**Engineering Statement
Prepared for Dane County
Re:
Proposed WBKY Tower Site #2157
Township of Rutland
Application for CUP**

January 25, 2011

**Evans Associates Consulting Engineers
216 Green Bay Rd., Suite 205, Thiensville, WI 53092
Phone (262) 242-6000 Fax (262) 242-6045
www.evansassoc.com**

Figure 1 – Site Location Area

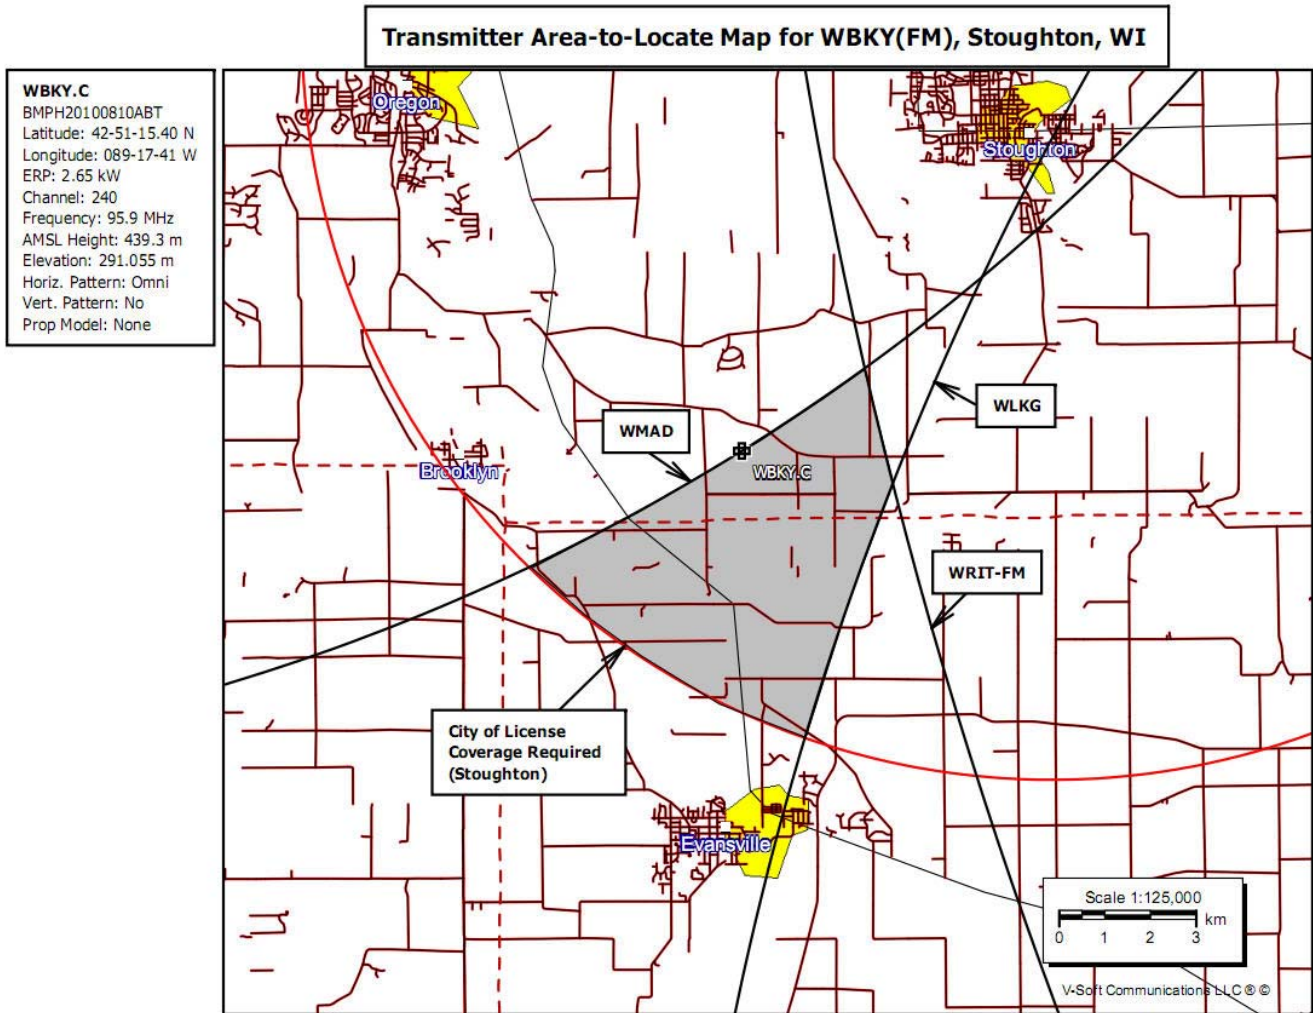
Figure 1, attached, shows the area within which the tower may be located according to the FCC's allocation and city coverage rules. There are no known FCC registered towers within this area, the closest being only 200' high and outside of the siting window. It should be noted that cell towers under 200 feet do not require FCC registration.

Evans has rechecked the Magnum search area map, and the result is shown in Figure 1. The proposed site is located at the northwestern boundary of the area (see Section #9 of this report). It is the intent of the County’s Ordinance to populate the county with the minimum number of structures by requiring co-location. Since there are several Internet, cell and PCS providers in the Dane County area, additional providers could be expected to co-locate at this proposed site, especially as wireless Internet services become more prevalent. The tower will be placed near a gravel pit, and partially shielded by trees. In this engineer’s opinion, it probably would be difficult to replicate this confluence of factors within the remainder of the siting area.

Figure 2 – Propagation Map Using Proposed Facilities

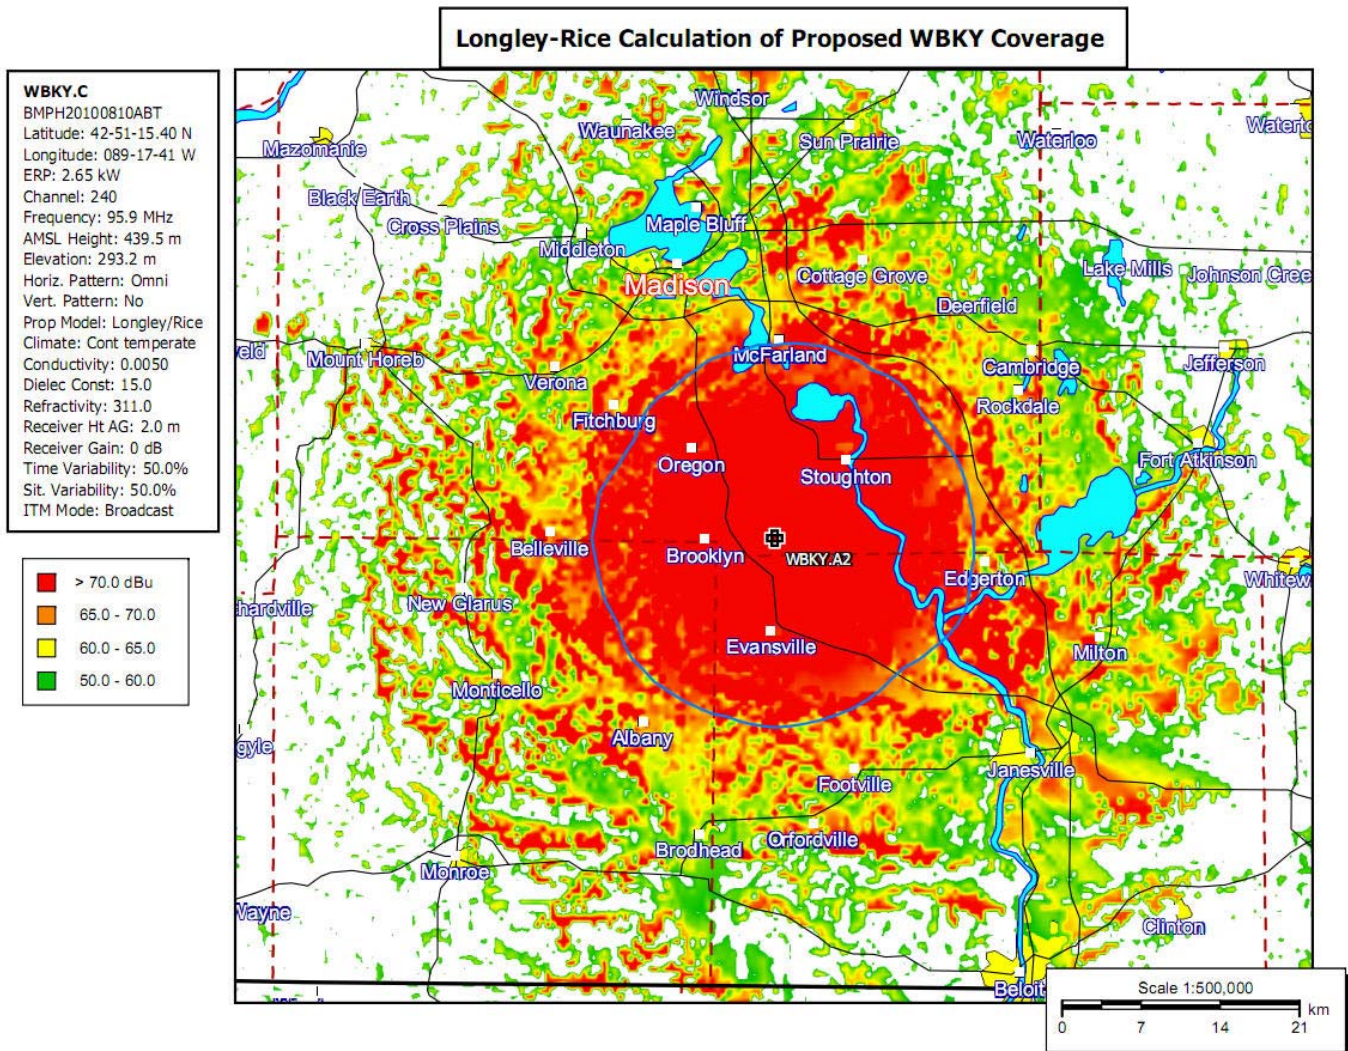
The attached figures 2, 3 and 4 show the level of reception to be expected at 488, 315, and 400 feet above ground level. The color scheme used for the attached propagation maps is as follows:

The best service among these three exhibits is rendered at 488 feet.

Figure 3 - Propagation Map at 315'

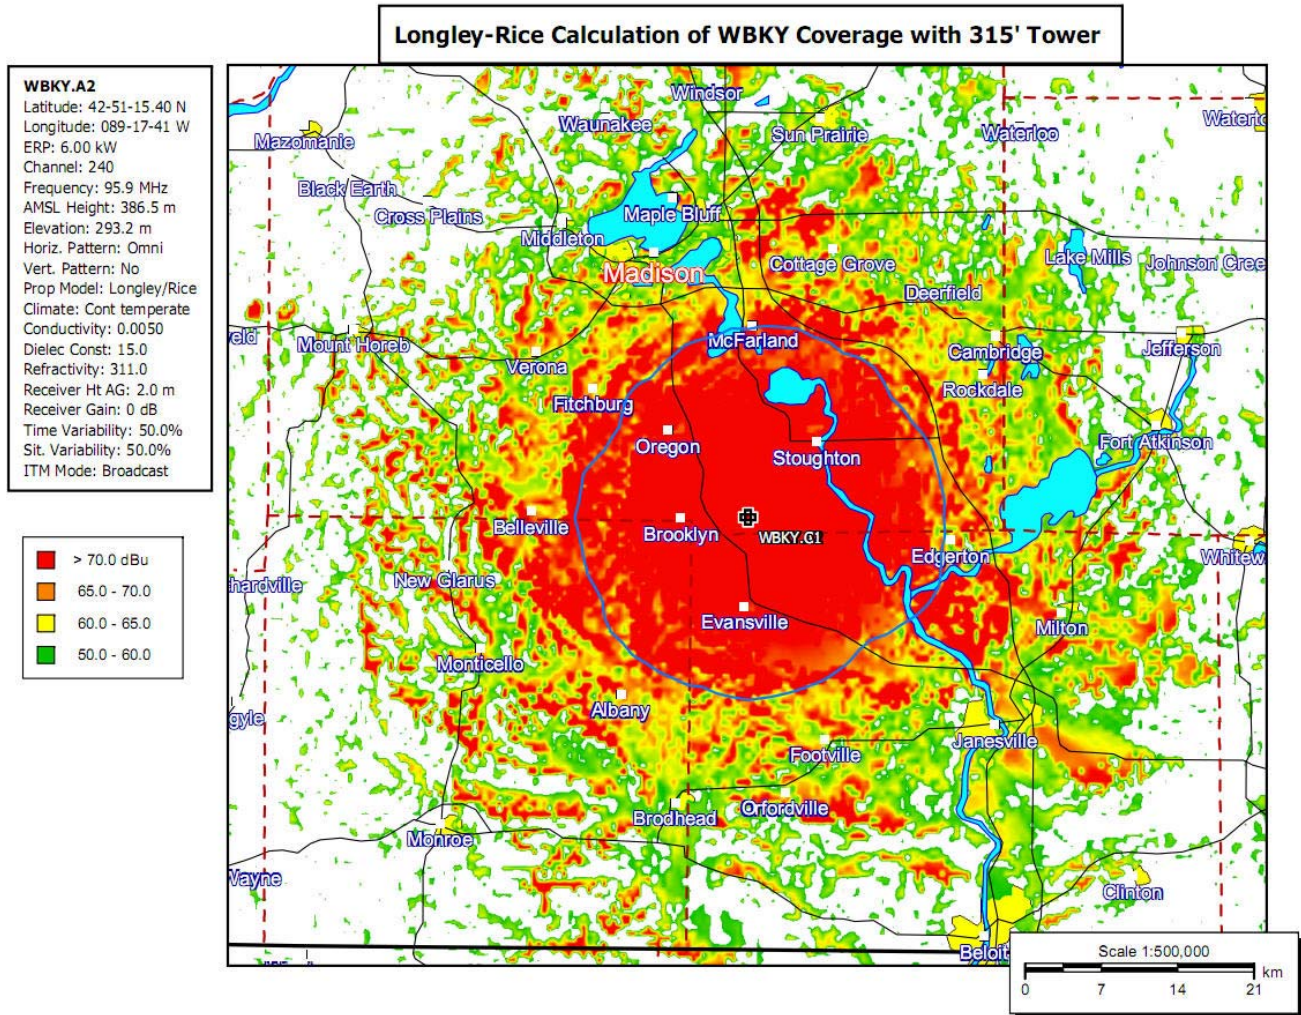
To evaluate the effect of shorter towers than that proposed, Evans ran propagation analyses at 315' and 400' in addition to the proposed height of 488 feet. In Magnum's opinion, the maximum height represents the minimum that will achieve the required technical objectives. The attached propagation maps show the effect of decreasing tower height, and paragraph III-5 shows the relative population associated with each. While the 315'⁴, 400' and 488' maps show definite differences in coverage, it certainly may be argued that the difference in performance between a tower of an intermediate height, say 450', would be minor compared to that at 488'. However, the differential visual impact would be minor as well, thereby achieving a dubious benefit.
